SERIAL: BSEP 04-0091  
TSC-2004-02

Subject: Brunswick Steam Electric Plant, Unit No. 2  
Docket No. 50-324/License No DPR-62  
Request for License Amendment - Addition of TRACG Methodology for  
Determining Core Operating Limits

**Marked-up Technical Specification Pages - Unit 2**

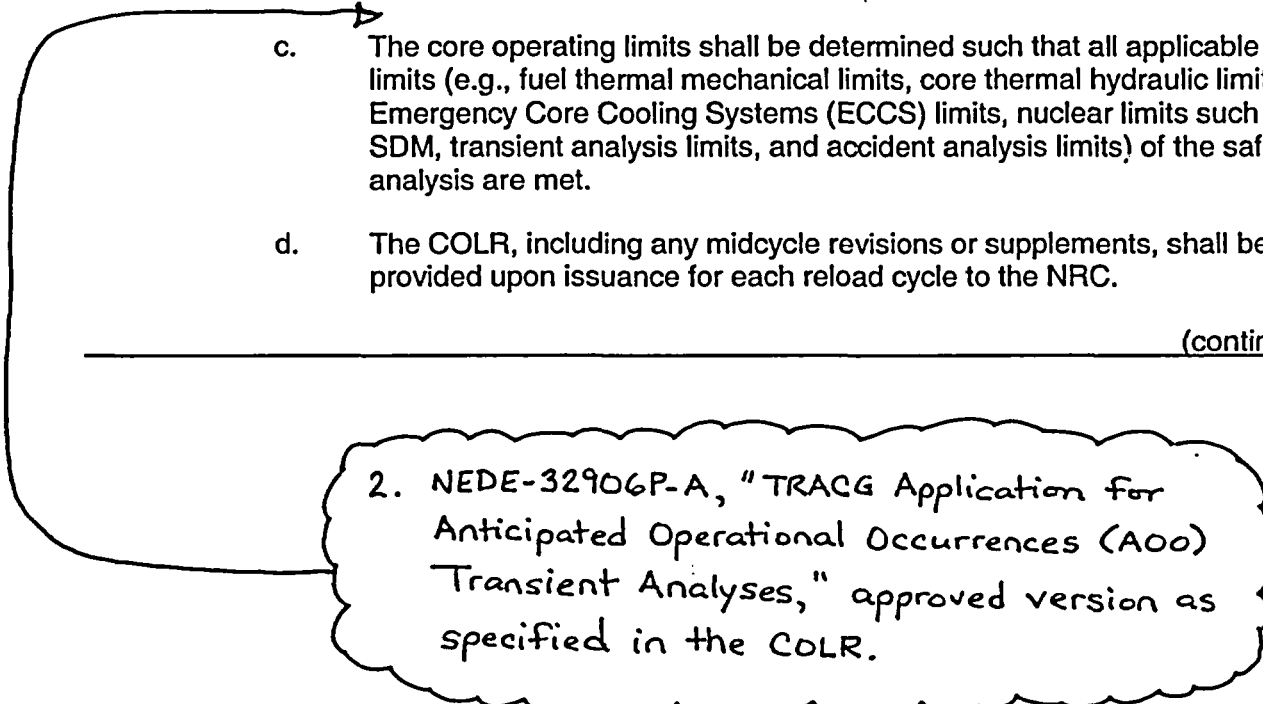
2. NEDE-32906P-A, "TRACG Application for Anticipated Operational Occurrences (AOO) Transient Analyses," approved version as specified in the COLR.
